ADDENDUM NO. 1

Bid #1506
ORANGE EDUCATION CENTER PORTABLES PHASE II
at
ORANGE EDUCATION CENTER

Project ID #3762, DSA #04-125366

ADDENDUM 1

A7.09-2

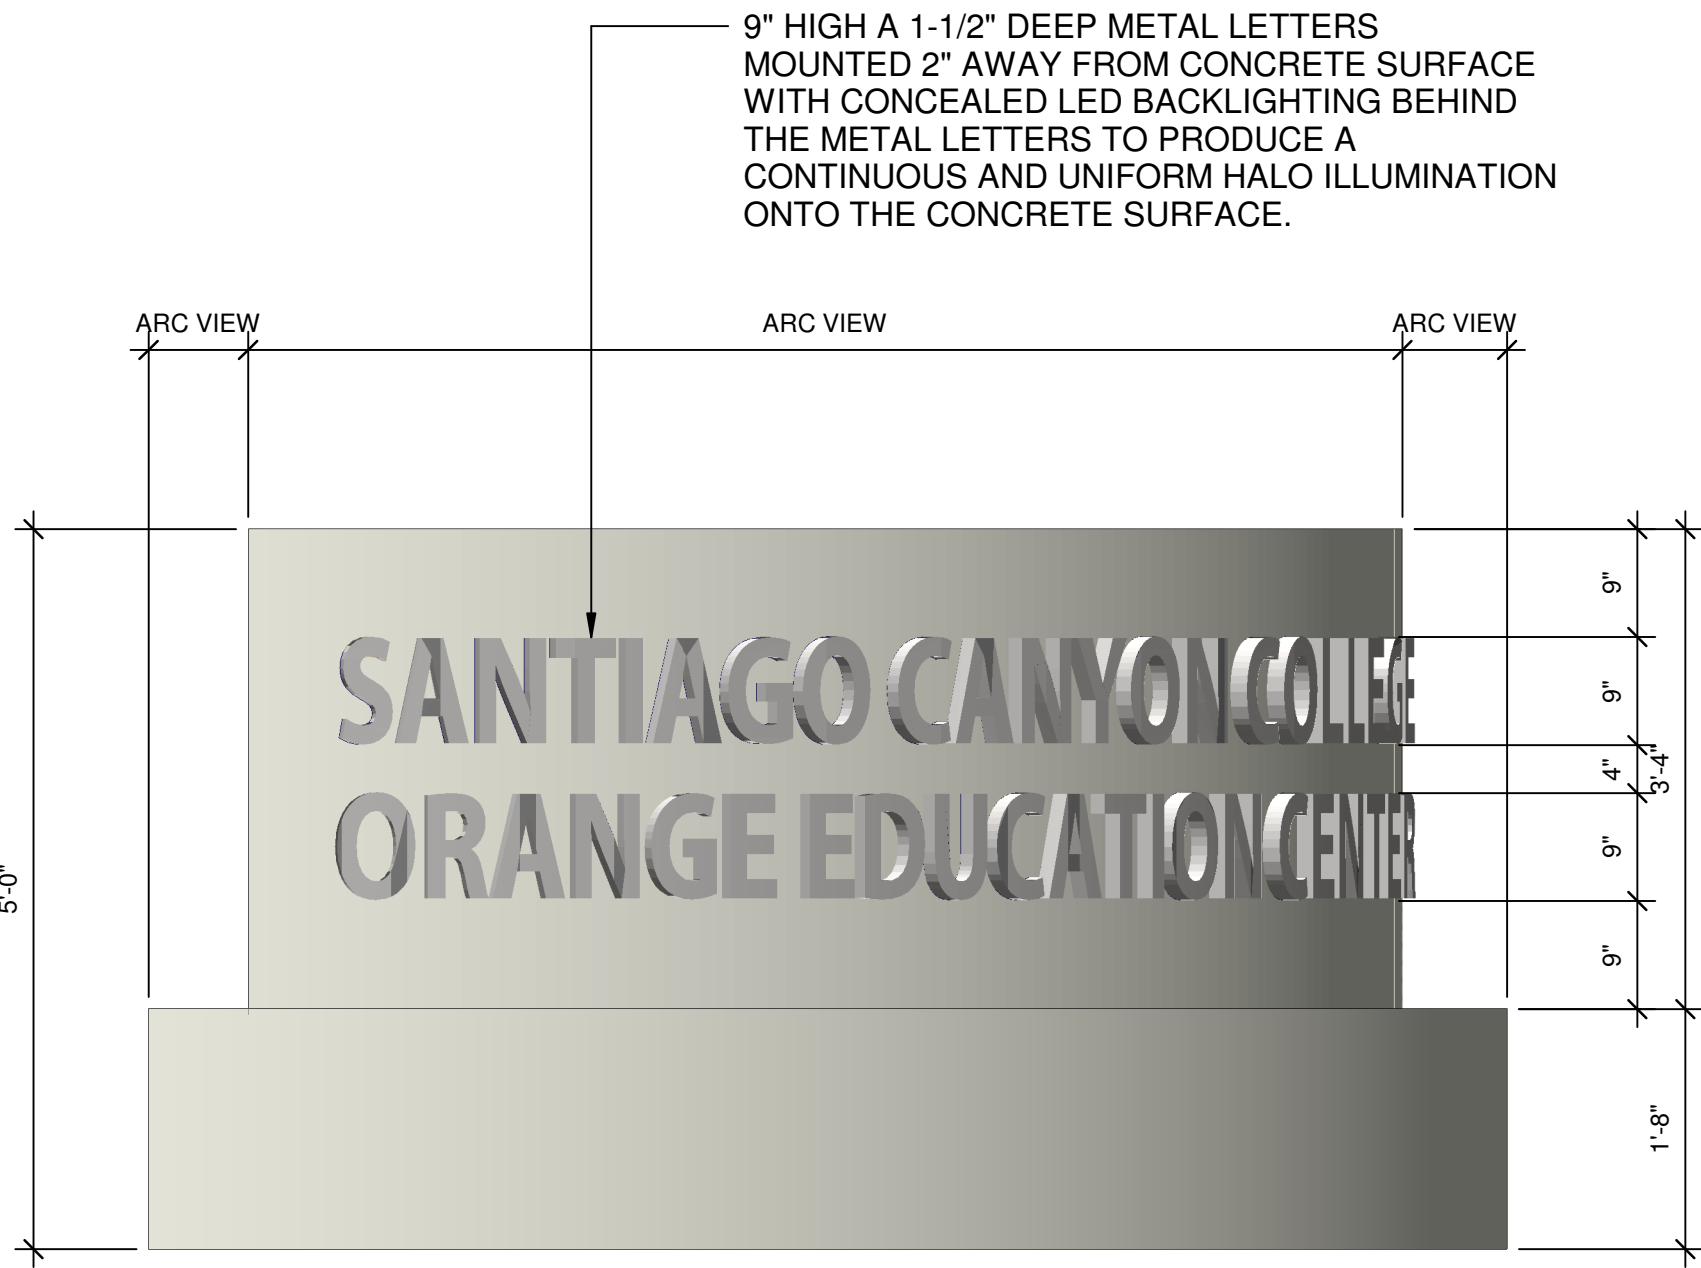
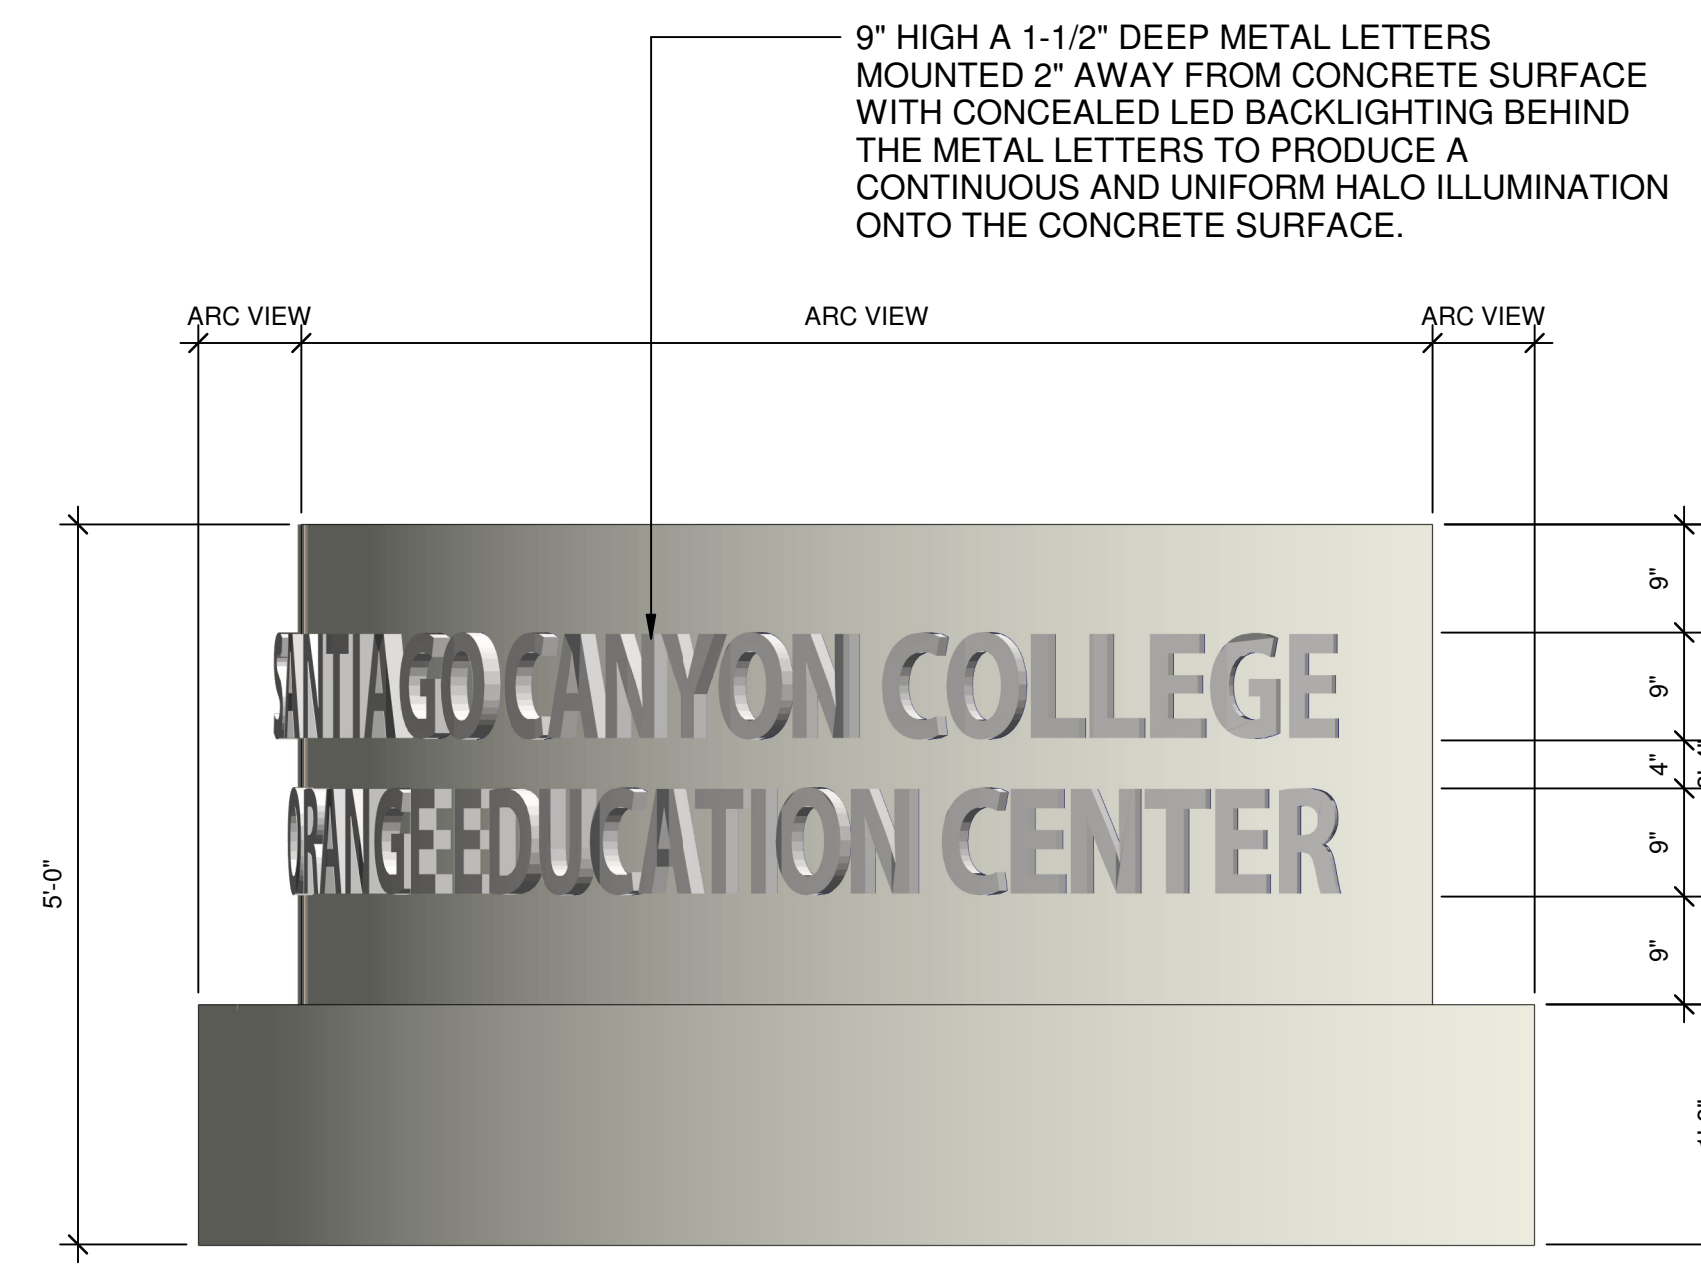
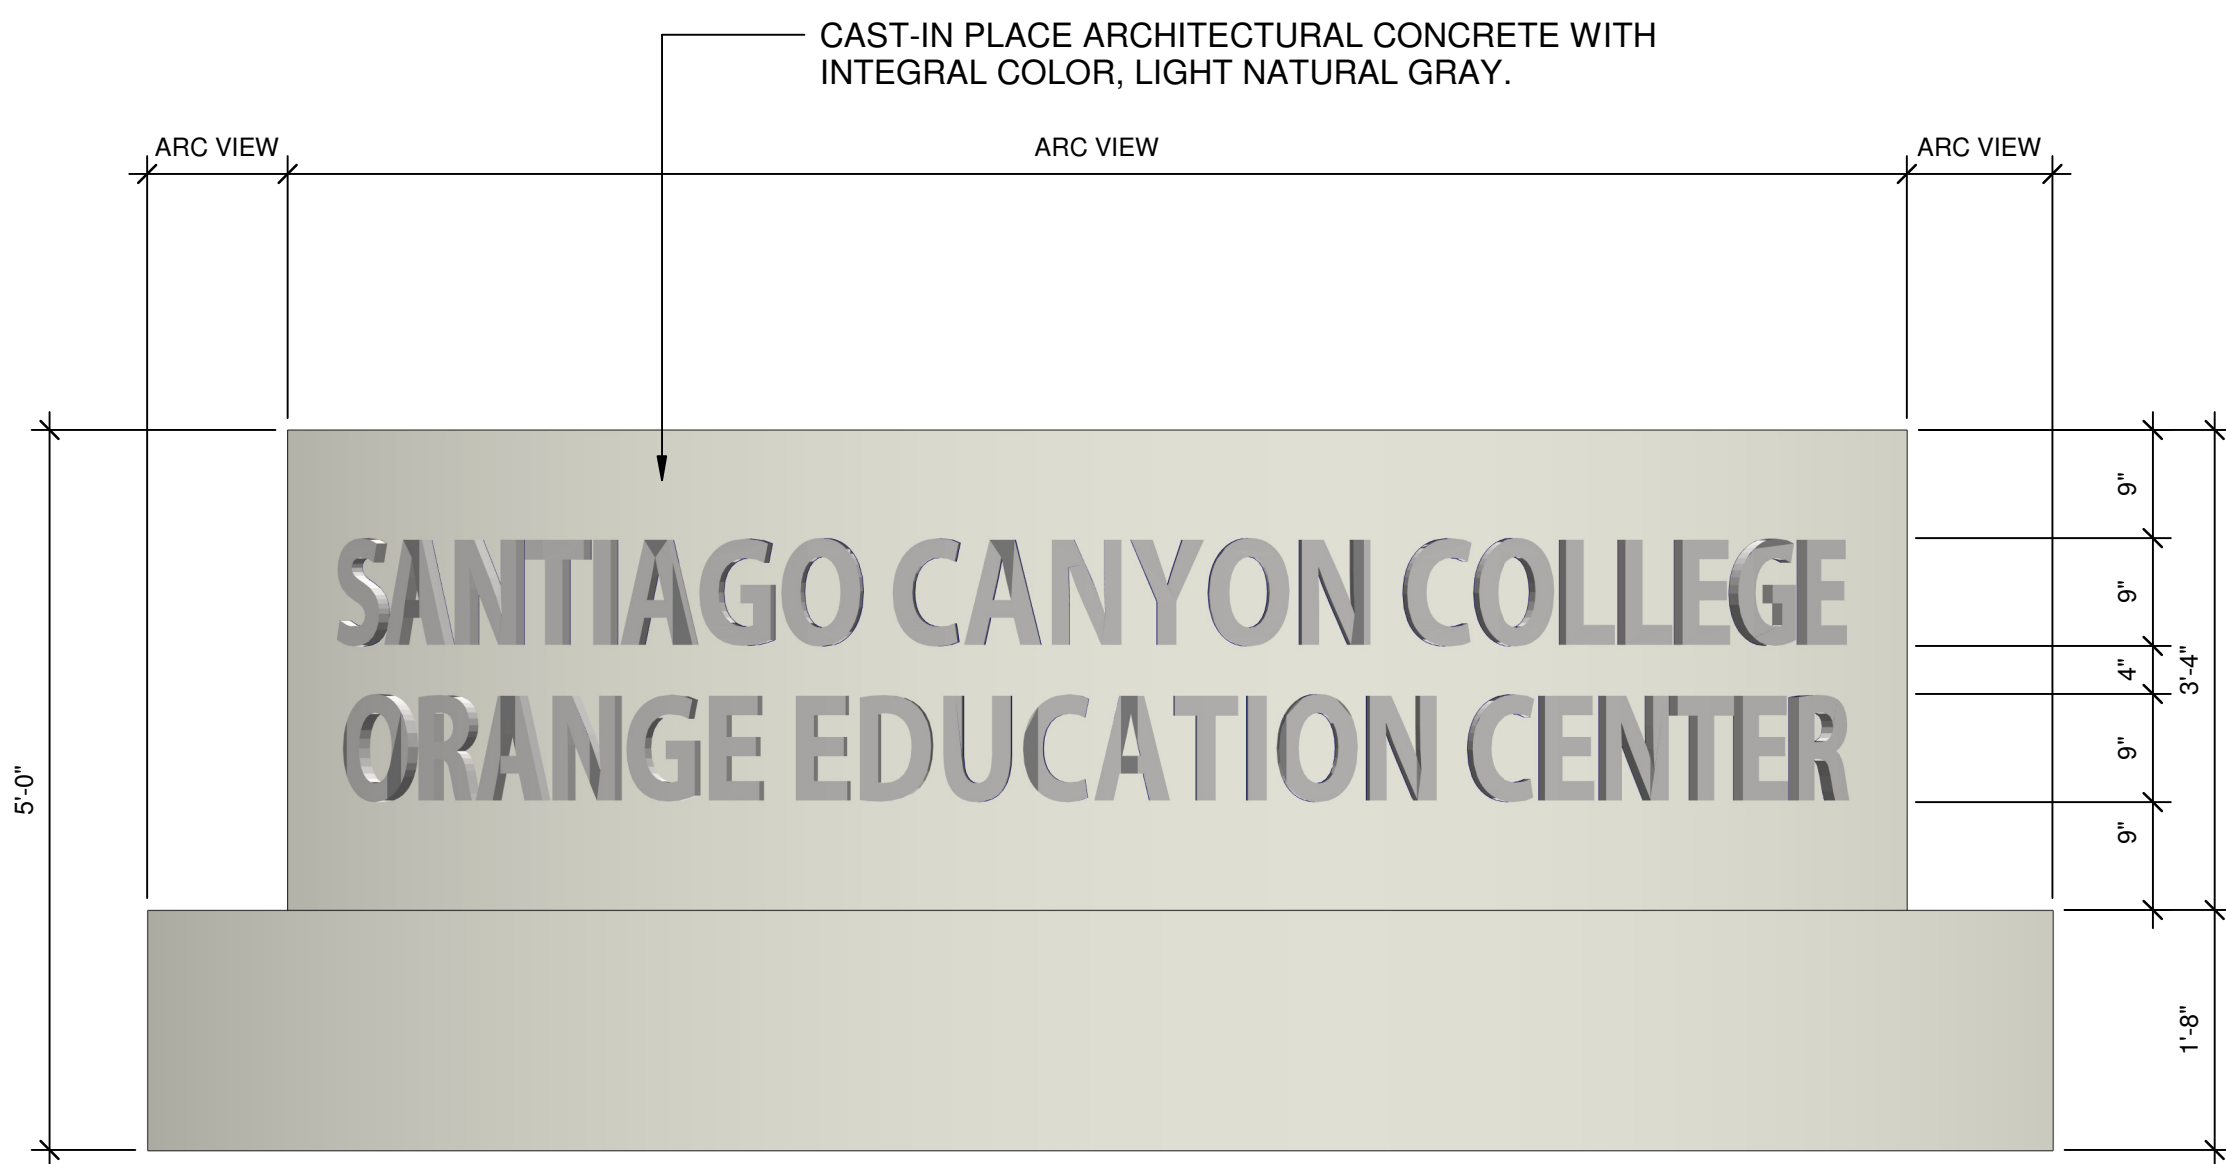
8. **A6.01-2:**
 - A. The detail for mounting methods of signage has been adjusted to clarify interior and exterior applications.
9. **A7.09-2:**
 - E. Sheet added for monument sign details.
